LOCAL PLANNING APPEAL TRIBUNAL

Supplementary Witness Statement of Harry Froussios, MCIP, RPP

REPLY TO SUPPLEMENTARY STATEMENT OF ANTICIPATED EVIDENCE – JIM MCCOOMB

LAKEVIEW CONDOMINIUMS  
PRESPA CONSTRUCTION LIMITED  
MUNICIPAL NO. 146-156 WILLIAM STREET

**Revised Prespa Site Plan  
February 27, 2019**

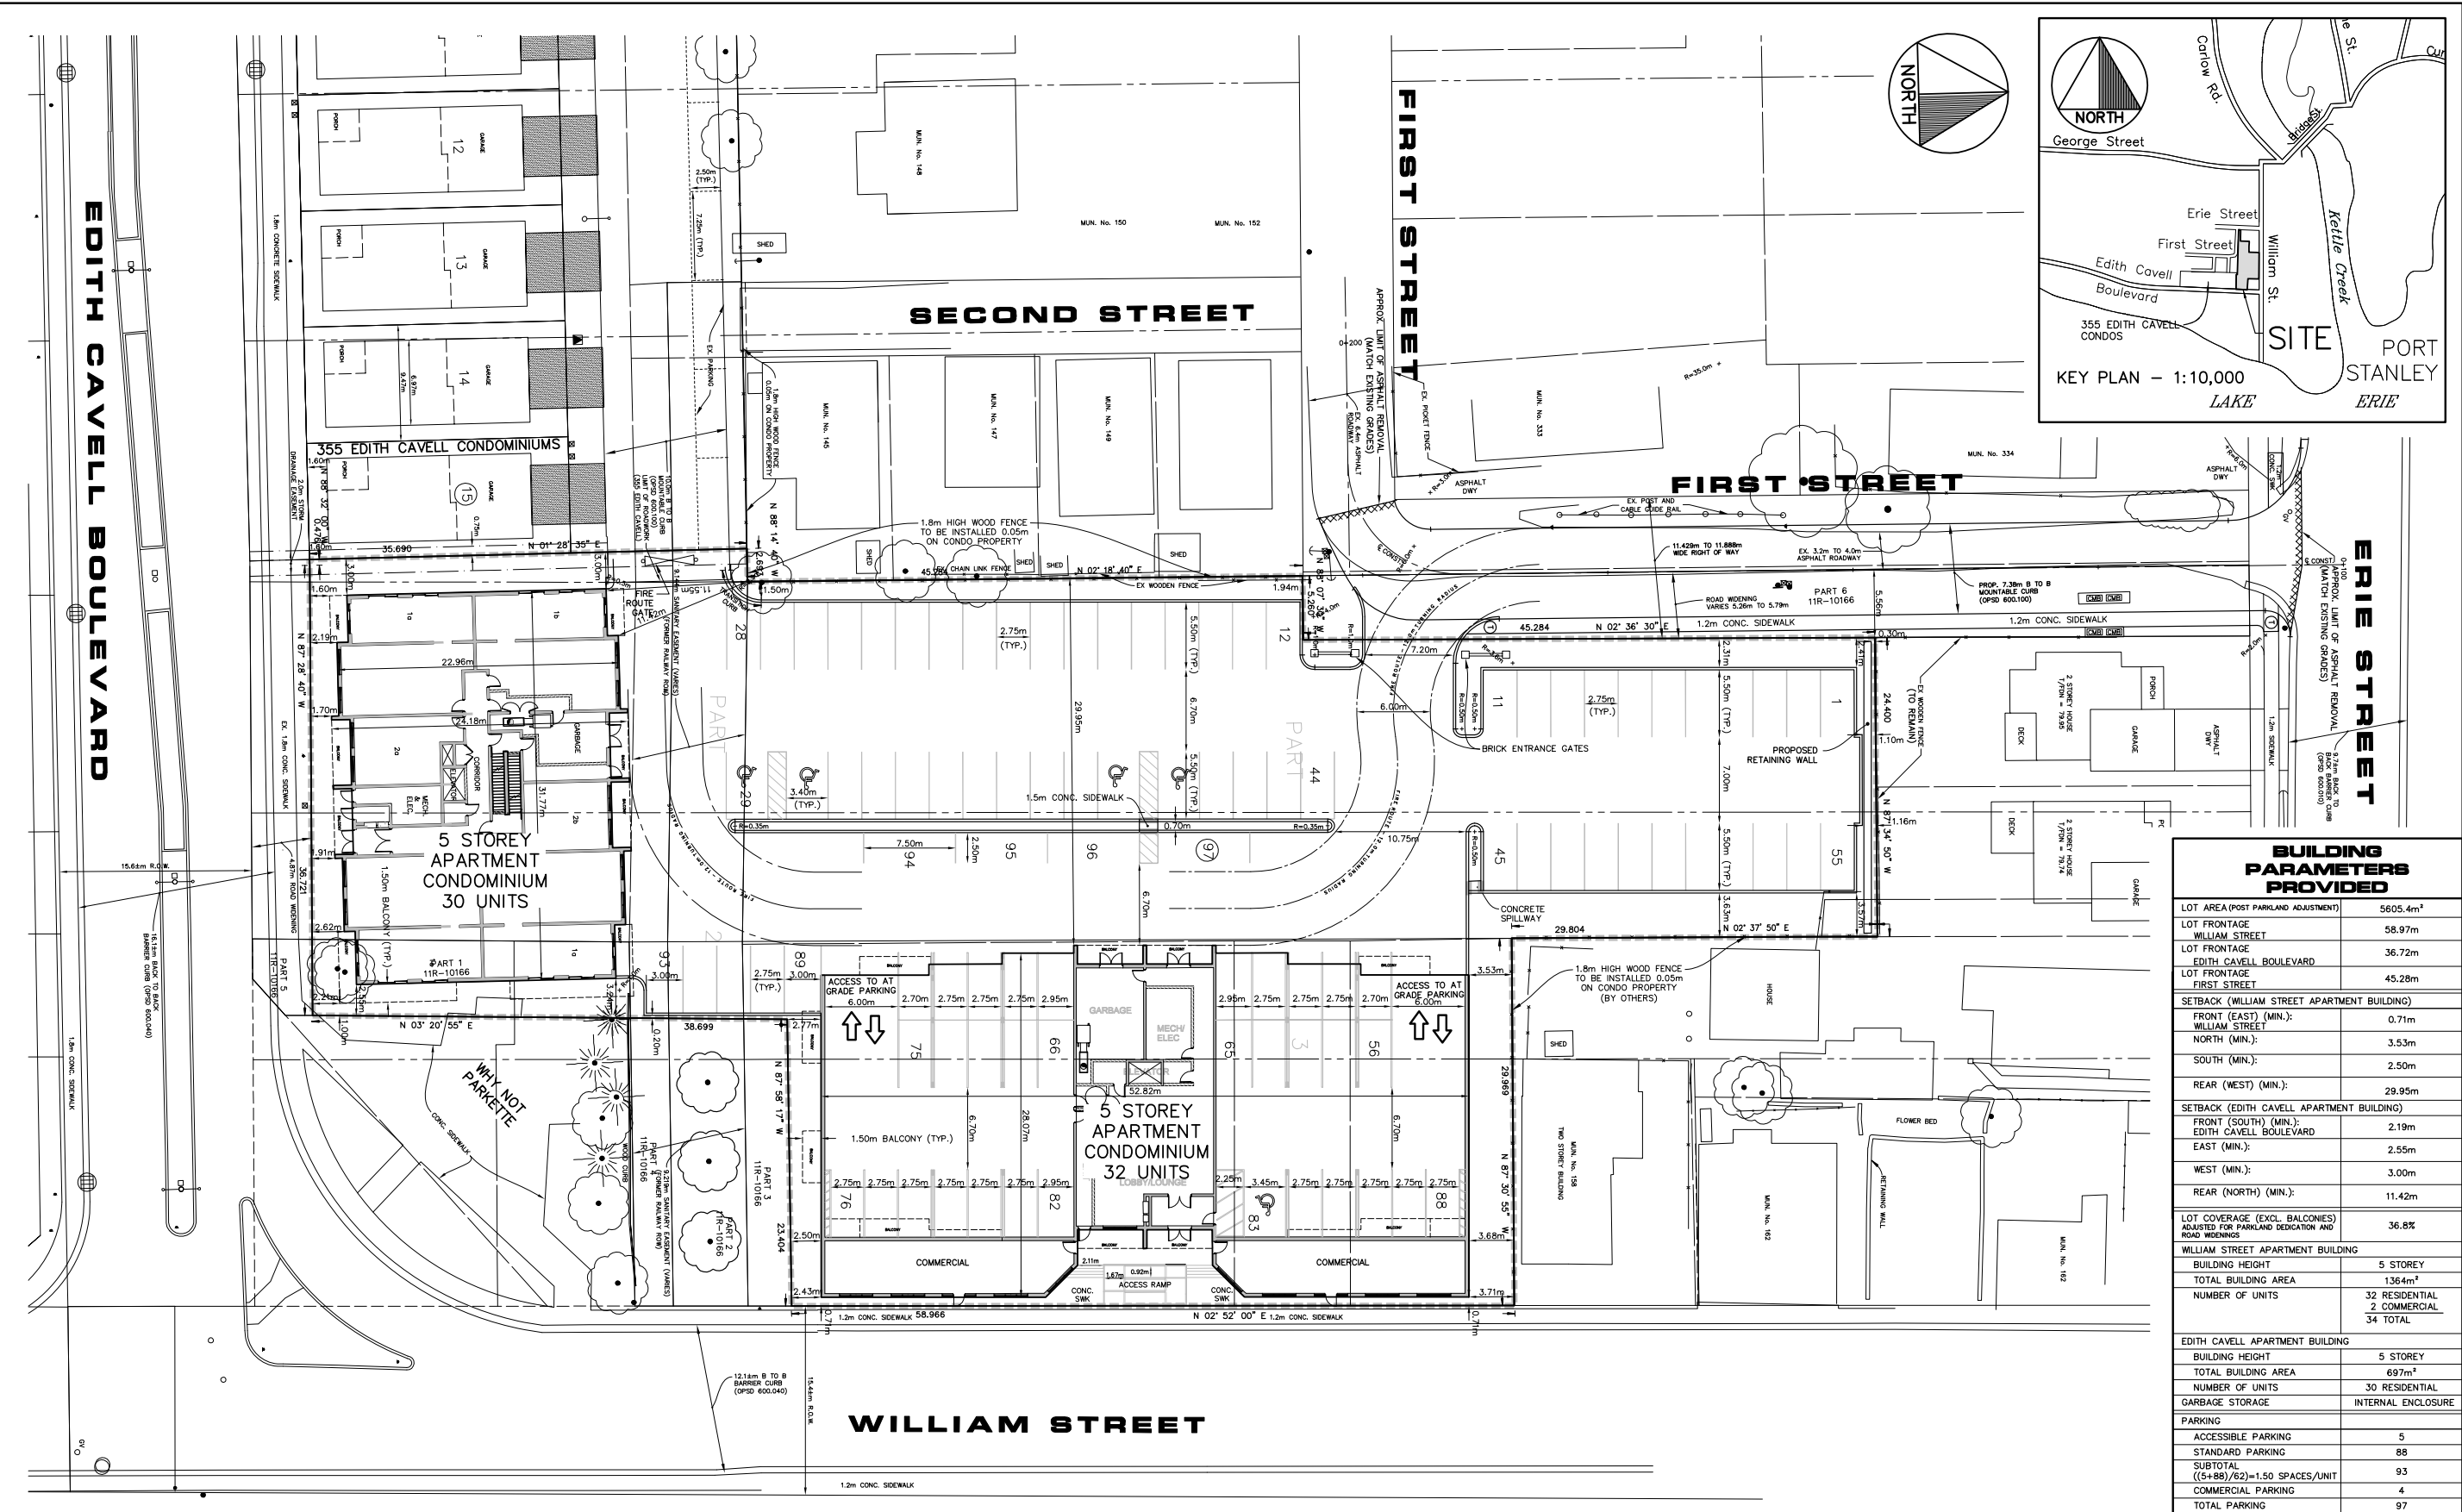
11. The revised site plan, attached as **Exhibit "A"**, has increased the proposed building setbacks and provides a minimum setback of 3.0m in the following locations:

- a) Mixed Use Building (Facing William Street)
    - North wall (facing abutting commercial use): 3.53m
  - b) Apartment Building (Facing Edith Cavell Boulevard)

- West wall (facing abutting residential use): 3.0m
12. It should be noted that the east wall of the mixed-use building is proposed to be situated within a site-specific Business 1 (B1) Zone and, as such, the 3.0m setback does not apply in this instance.

13. However, the revised site plan provides the following setbacks that do not comply with the proposed 3.0m minimum requirement to the following extent:

- a) Mixed Use Building (Facing William Street)
    - South wall (facing Why Not Park): 2.5m (min); 2.77m (max)
  - b) Apartment Building (Facing Edith Cavell Boulevard)

- South (main) wall (facing Edith Cavell Boulevard): 2.19m (min); 2.62m (max)
    - East wall (facing Why Not Park): 2.55m (min); 3.24m (max)
14. The revised site plan ensures that the minimum 3.0m setback proposed by the Municipality is achieved between the proposed building and adjacent residential or commercial uses,

15. While the proposed setbacks adjacent to Why Not Park are less than 3.0m, in my opinion, the proposed setbacks of at least 2.5m are appropriate considering the nature (park) and zoning (Open Space – OS3) of the abutting lands and that no habitable buildings are present. Furthermore, the difference between the required setback and the proposed setback in the revised site plan (0.5m) will not create any adverse impacts on the abutting open space use. It should also be noted that the proposed minimum setbacks abutting Why Not Park relate only to the first 3 storeys of the buildings. The 4<sup>th</sup> and 5<sup>th</sup> storeys will be setback at a greater distance from the property line.

16. The reduced setback abutting Edith Cavell Boulevard is consistent with, and larger than, the existing setbacks of the abutting residential buildings to the west (1.6m), thus establishing a consistent streetscape along the Edith Cavell Boulevard road allowance.

17. In my opinion, the proposed setbacks shown in the revised site plan are appropriate and provide the desired spatial separation from adjacent buildings; provide appropriate opportunities for landscaping and buffering; are consistent with the current streetscapes along William Street and Edith Cavell Boulevard; and do not create unacceptable adverse impacts on surrounding properties.

18. As such, it is recommended that Section 9.2.3.2.8 of the draft ZBA be revised to be consistent with the setbacks shown in the revised site plan.

26. As such, in my opinion, it is recommended that Section 9.3.2.3.9 of the draft ZBA be deleted as it is not appropriate or desirable for the proposed development.
